ECE/TRANS/WP.29/2009/13  
17 December 2008

Proposal for Supplement 18 to the 01 series of amendments to Regulation No. 6  
(Direction indicators)

Submitted by the Working Party on Lighting and Light-Signalling (GRE) \*/

On and above the H plane  
for all lamps.

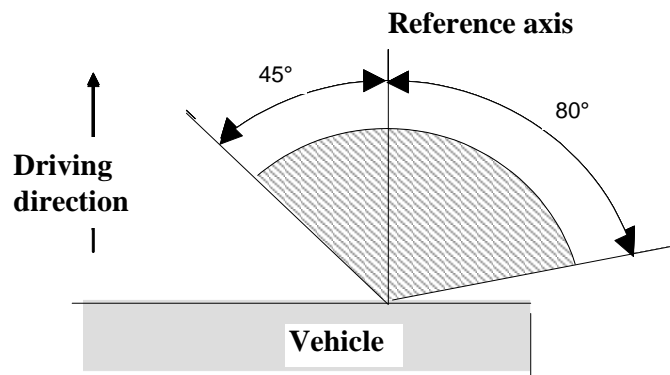
Annex 1, amend to read:

Minimum horizontal visibility angles

Direction indicators for the front of the vehicle

Category 1: for use at a distance not less than 40 mm from the headlamp;

Category 1a: for use at a distance greater than 20 mm but less than 40 mm from the headlamp;

Category 1b: for use at a distance less than 20 mm from the headlamp.

Under the H plane for  
lamps intended for M<sub>2</sub>, M<sub>3</sub>  
or N<sub>2</sub> category of vehicles

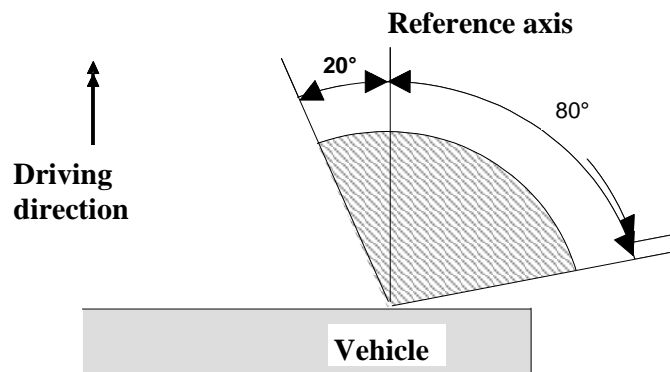
Under the H plane for  
M<sub>1</sub> and N<sub>1</sub> category of  
vehicles
